CHARLESTON/ARASTRADERO CORRIDOR PLAN

Final *Initial Study and* *Mitigated Negative Declaration* *January, 2004*

*Mitigated Negative Declaration
Public Review Comments
And
Responses to Comments*

Subject: City File No.: 03-EIA-16 / Charleston-Arastradero Corridor Plan

Proposed Arastradero Road/Charleston Road Bus Stop Improvements

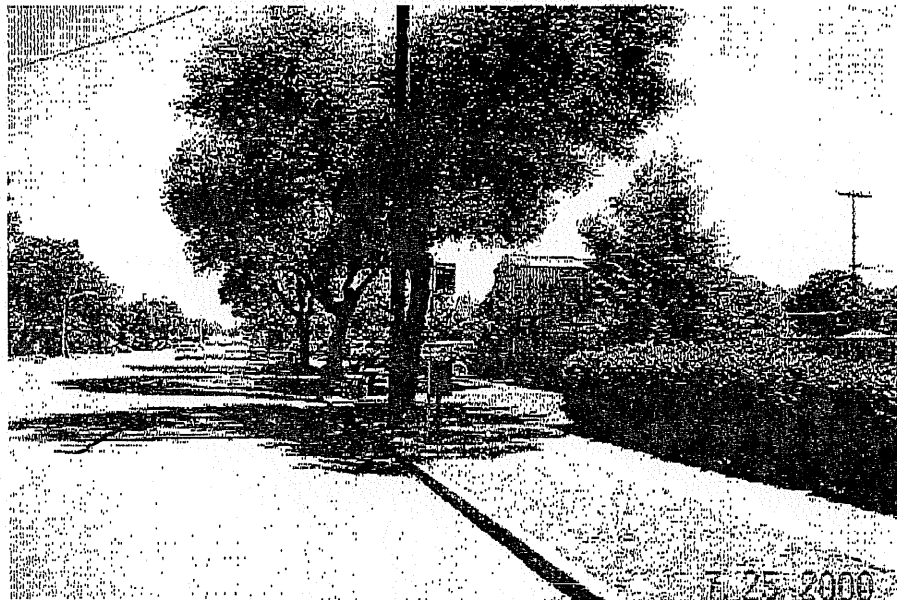
(1) #148005 WB Charleston Rd. NS Grove
*Fill in planter strip, 40' long Passenger Waiting Pad
*Install 10'x55' PCC Bus pad

(2) #148014 EB Charleston Rd. FS Sutherland Drive
*Fill in planter strip, 40' long Passenger Waiting Pad
*Install 10'x55' PCC Bus Pad

Response: The comment is noted. The City will coordinate with the VTA regarding the construction or improvements for bus stops during further design development and prior to implementation of Plan projects.

Proposed Arastradero Road/Charleston Road Bus Stop Improvements

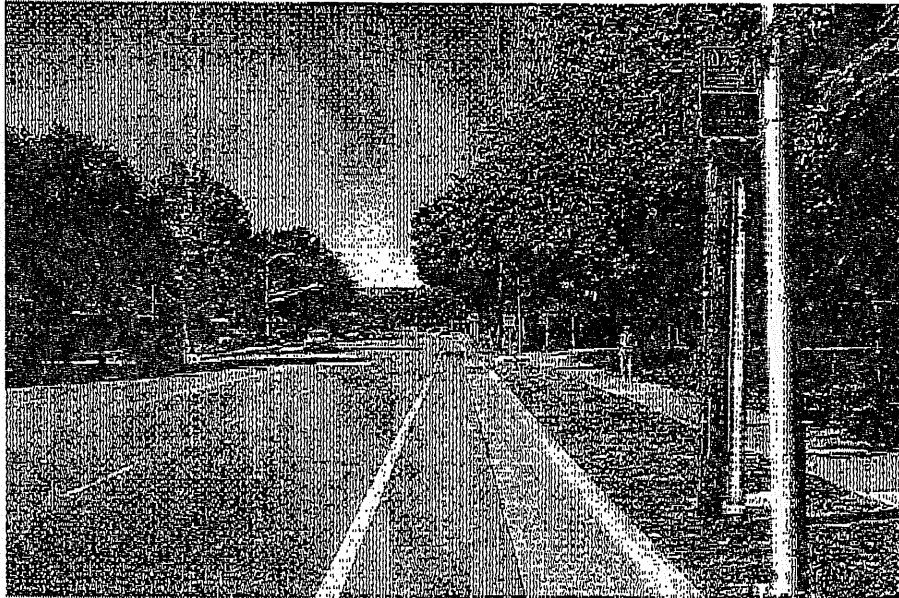
(5) #138002 EB Charleston Road NS Nelson Drive
*Install 10'x55' PCC Bus Pad or Repair Damaged Curb & Gutter

(6) #138003 WB Charleston Road At Stevenson House
*Fill-in Additional Planter Strip W/ PCC For Access to Rear Door of Bus
*Install 10'x55' PCC Bus Pad

Proposed Arastradero Road/Charleston Road Bus Stop Improvements

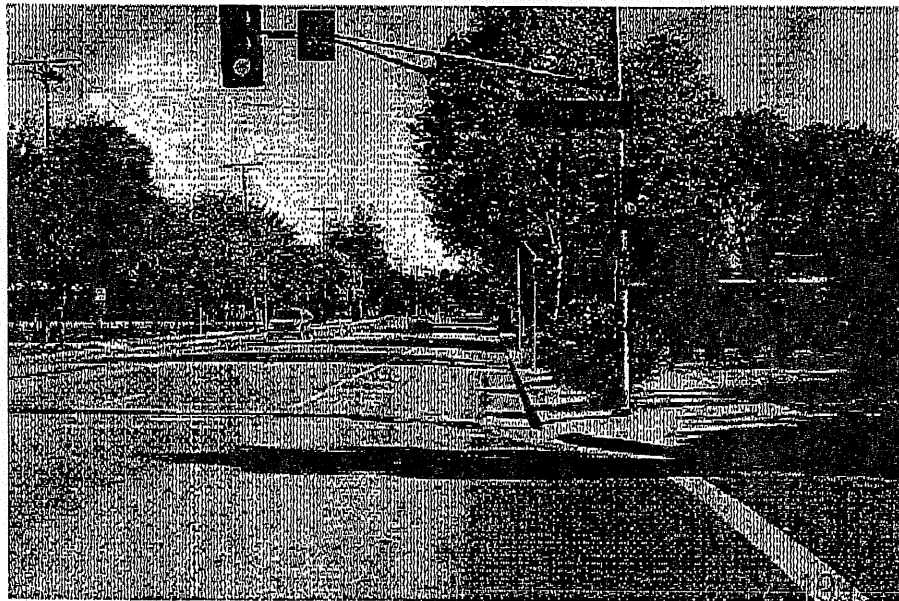
(7) #138008 WB Charleston Road NS Carlson Court
*Fill-in Planter Strip W/ 40' Long PCC Passenger Waiting Pad
*Install 10'x55' PCC Bus Pad

(8) #138009 EB Charleston Road FS Carlson Court
*Remove Shrubs, Fill-in Planter Strip W/ 40' Long PCC Passenger Waiting Pad
*Install 10'x55' PCC Bus Pad

Proposed Arastradero Road/Charleston Road Bus Stop Improvements

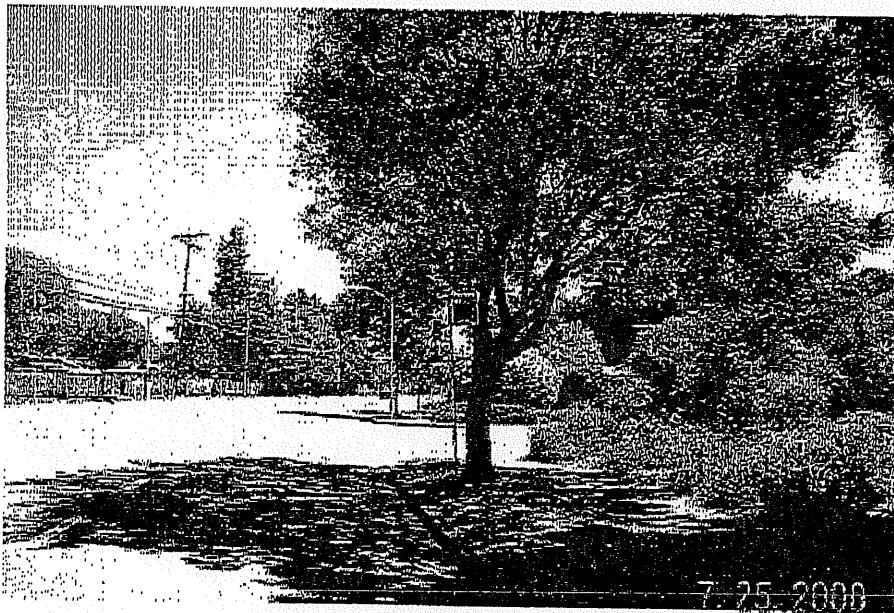
(9) #138006 WB Charleston Road NS Wright Place
*Install 10'x55' PCC Bus Pad

(10) #138007 EB Charleston Road NS Mumford Place
*Fill-in Planter Strip W/ 40' Long PCC Passenger Waiting Pad
*Install 10'x55' PCC Bus Pad

Proposed Arastradero Road/Charleston Road Bus Stop Improvements

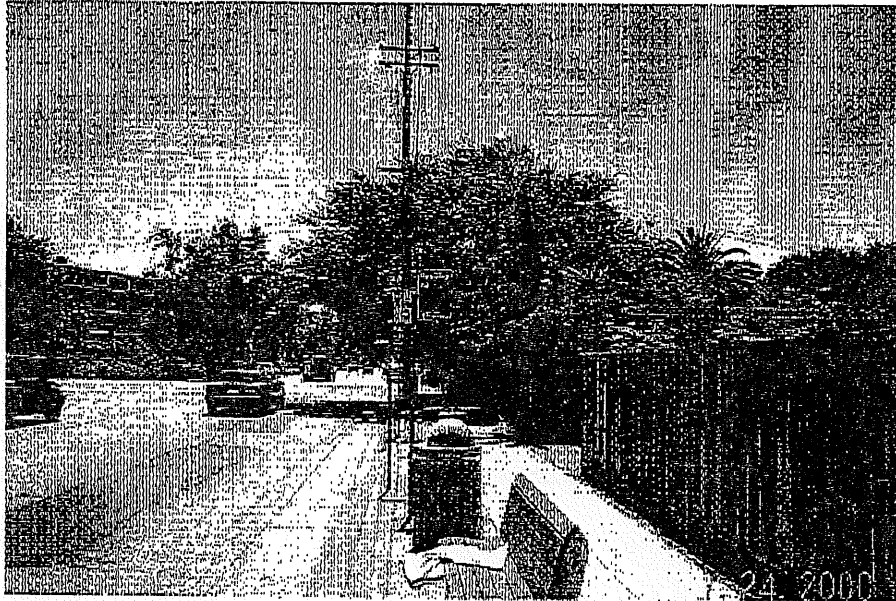
(13) #127910 EB W. Charleston Road NS Ruthelma Ave.
*Install 10'x55' PCC Bus Pad

(14) #127908 EB W. Charleston Road FS El CaminoReal
*Install 10'x55' PCC Bus Pad

Proposed Arastradero Road/Charleston Road Bus Stop Improvements

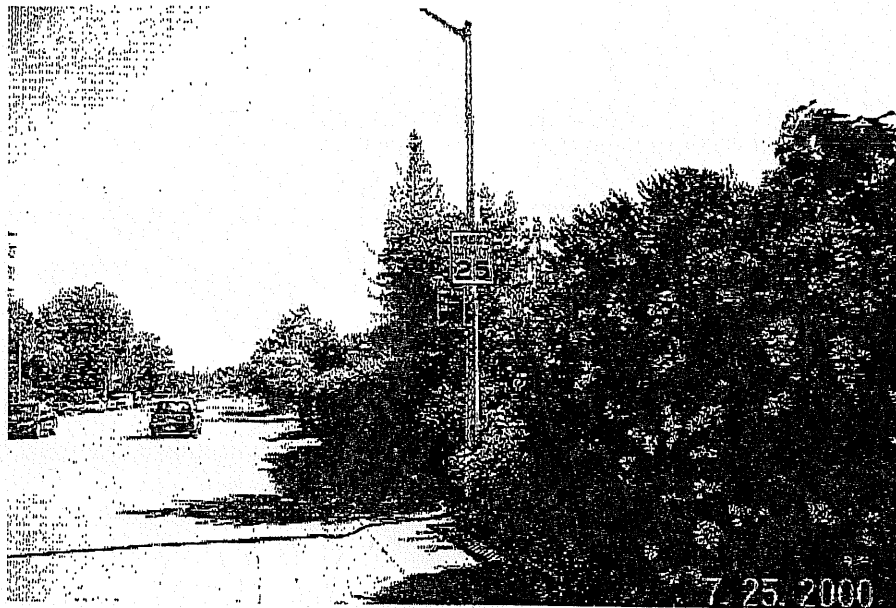
(15) #127909 WB Arastradero Road FS El Camino Real
*Install 10'x55' PCC Bus Pad

(16) #127804 WB Arastradero NS Coulombe Drive
*Install 10'x55' PCC Bus Pad
